RE: Environmental Assessment; Dominion New Market Project: CP 14-497-000

Please accept the following comments regarding the Environmental Assessment prepared by your staff for the Dominion Transmission, Inc. "New Market Project" (CP14-497-000).

FIGURE 5
Formaldehyde Levels Near Gas Pipeline Compressors that Exceed Health-Based Standards

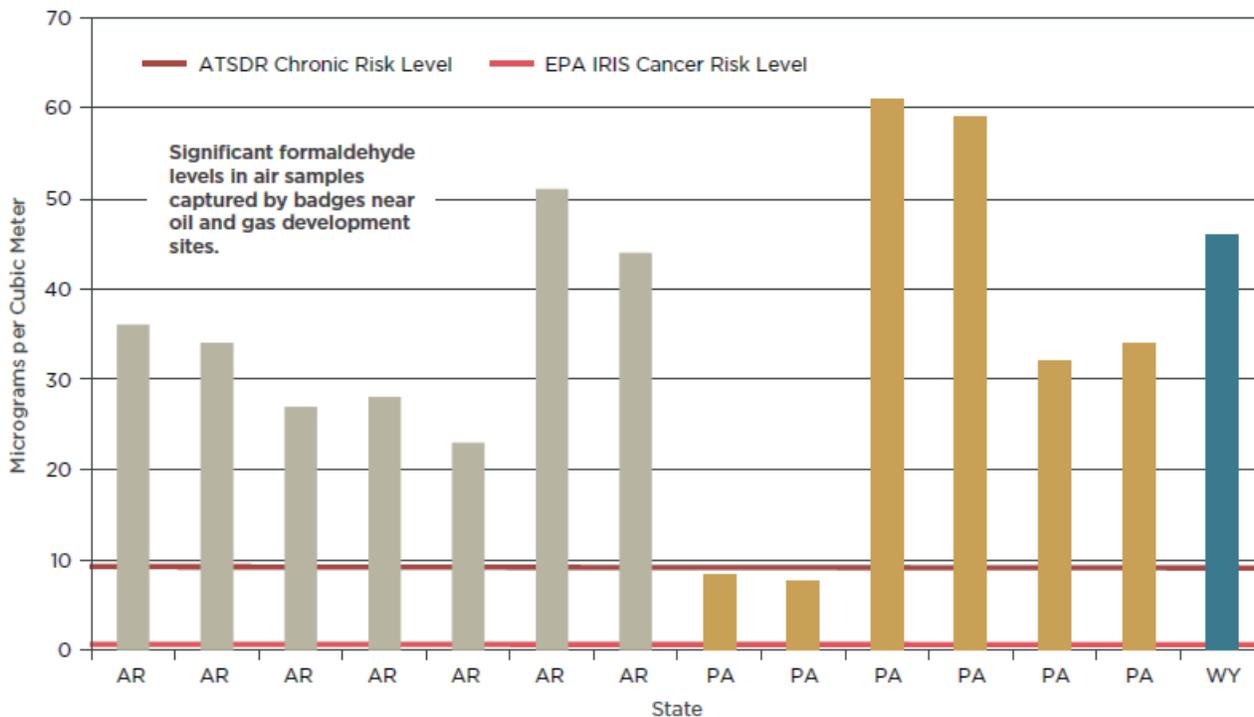
Each of the above compressor stations are facilities that received requisite federal and state approvals. Nonetheless, in practice emission levels greatly exceeded safe health standards. It is not convincing to relying on models that are ultimately inconsistent with reality. Clearly there are emission events or sources that the modeling performed by FERC fail to capture. For example, the report concludes that the impact of full station ESD blowdowns would occur only for “a short duration every five years and would not pose any discomfort, irritation, or mild health effects.” Yet emergency or maintenance blowdowns are known to occur much more frequently than this as unscheduled, and sometimes unreported events. As described in the Environmental Assessment (EA, page 87), the goal of the blowdown model was only to determine the potential short-term (1-hour acute) from an “infrequent” full station blowdown. Longer term effects of exposure to more frequent blowdowns were not considered. Likewise the conclusion that odors are essentially only a concern during blowdowns and at the property line boundary is inconsistent with the observation of many who live near compressor stations. Rather than purely relying on modeled results, FERC should support research to determine why events in the field are worse than what its models predict. Also not captured in FERC’s modeling is improper practices, such as intentional venting at night. A realistic consideration of risk must consider the possibility of such activities.
